SERVICE BULLETIN

Number: SB0212

Subject: Spring stop on Prowler series mowers.

FIG. 2

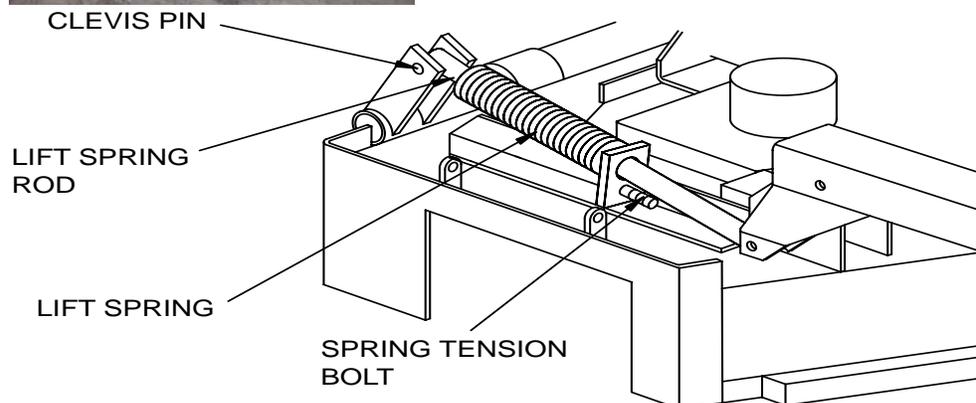
Part# 363007 bushing should be changed to Part # **592057 Lift Spring Bushing w/zerk**. You will also need to order **Part# 592006 Spring Retainer**.

To install the Bushing you must first block the deck and remove the pressure from the rear Clevis Pin on deck Lift Rod (Note: only remove one side and reassemble it before removing opposite side). After removing the clevis pin measure the length of the lift rod as the lift rod needs to be set back to this length after completion of assembly .

You may now relieve the pressure off the assist spring by loosening the 3/8 bolt holding (part # 592006) the spring stop. Now that the pressure is off the assist spring you may thread the lift rod apart by turning the back of the rod counter clock wise to remove the spring and bushing. Also at this time remove the spring stop and slide the new spring stop into place (note the new stop must be placed back on the lift rod with the welded side to the front of the deck). Place new spring bushing on to the lift rod (part #592057) also place spring back in position. Before threading lift spring rod back together start the spring tension bolt into the spring stop so that the bolt is flush with the back side of the stop. Now thread the rod back to the length measured. Tighten spring tension bolt all the way so that the stop is tight to the deck. Replace the clevis pin, add one pump of grease to the Zerk. Repeat procedure on opposite side.
